# 2015 - 2016 Corvette: Service Bulletin: #16-NA-014: Delayed Engagement After Sitting With Engine Off

## #16-NA-014: Delayed Engagement After Sitting With Engine Off - (Jun 28, 2016)

**Subject:** Delayed Engagement After Sitting With Engine Off

## **Correction**

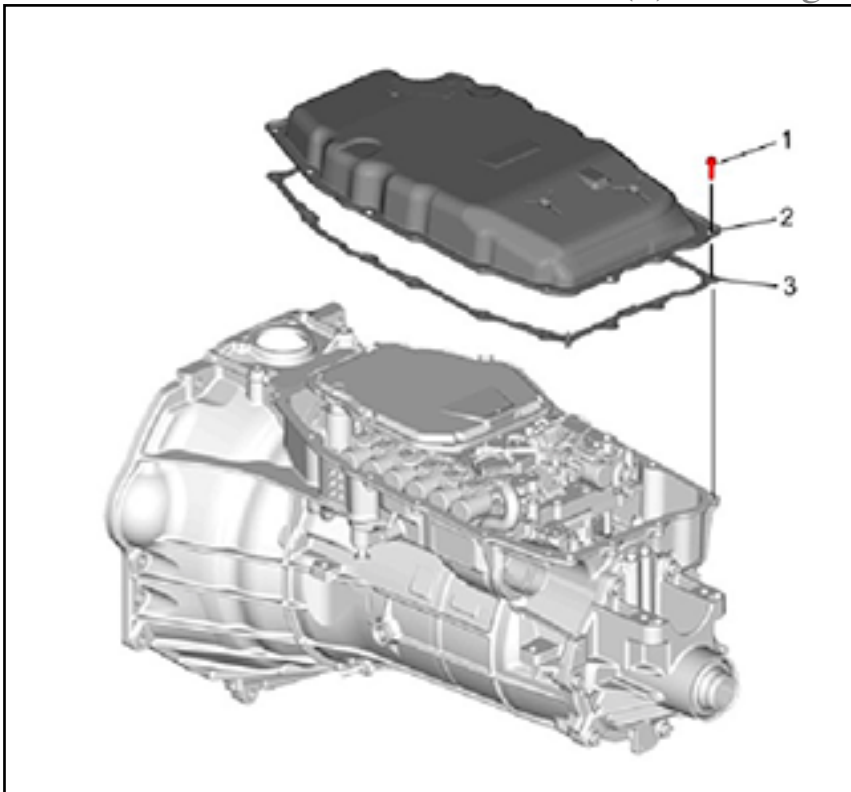
Install a new stator shaft support assembly that includes an additional check ball. Follow the instructions below to replace the stator shaft

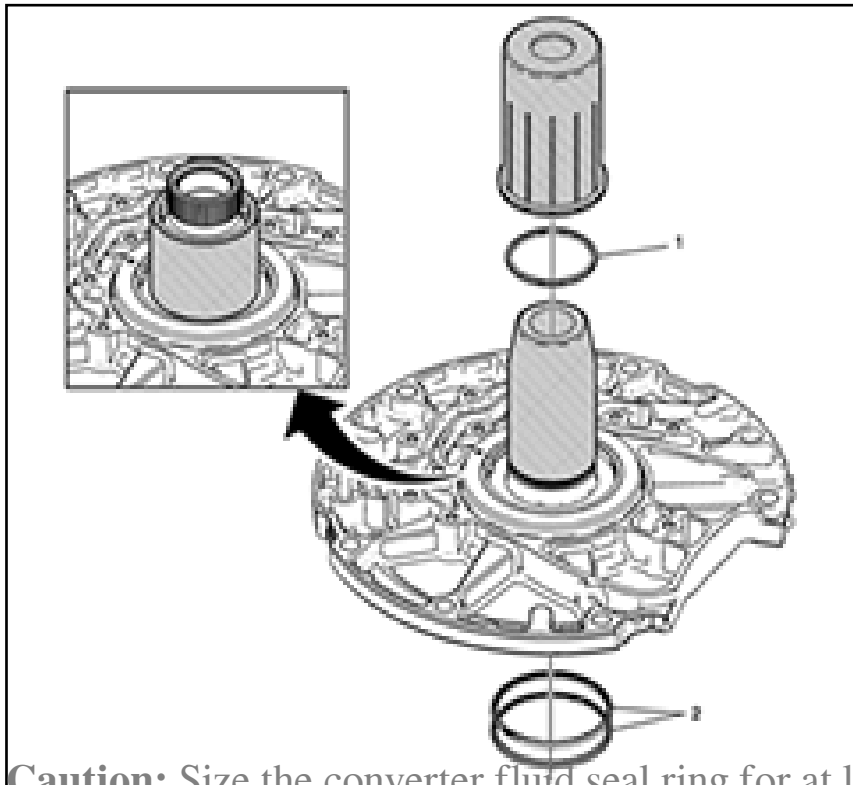
**Note:** The new stator shaft support assembly has a second check ball (1) added (see illustrations).

1. Install the NEW stator shaft support assembly (1).
2. Install the nine stator shaft support bolts (2). Tighten the bolts in the sequence shown. Tighten the bolts to  $31 Y$  ( $23 lb ft$ ).
3. Install a NEW turbine shaft O-ring seal (3).

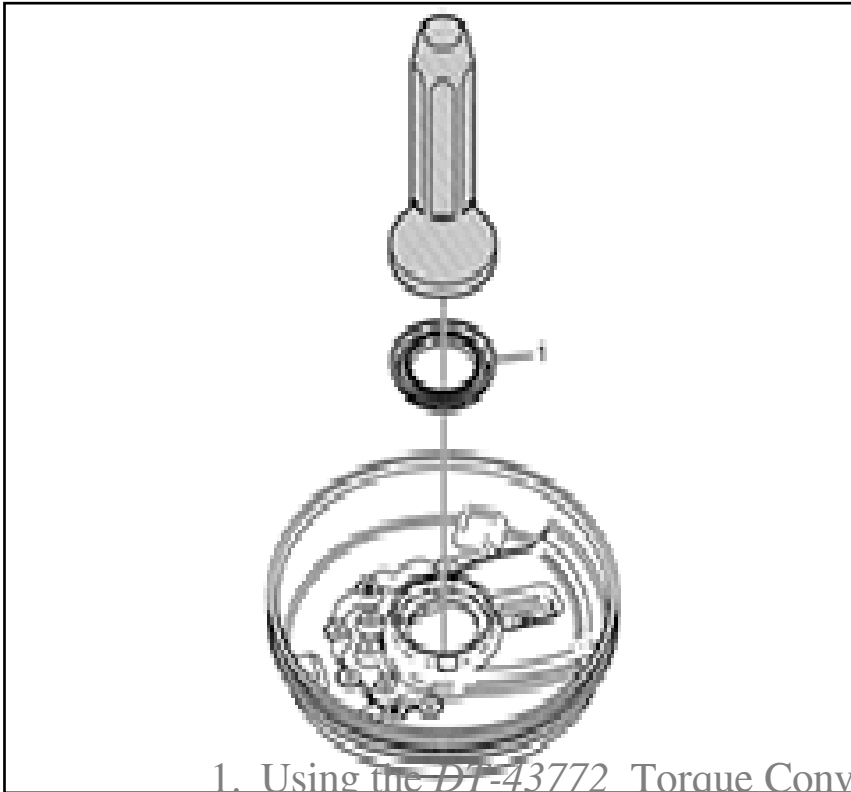
**Note:** The casting void has been eliminated from the underside of the cover for the 8L90 only (see illustration). The 8L45 is not required.
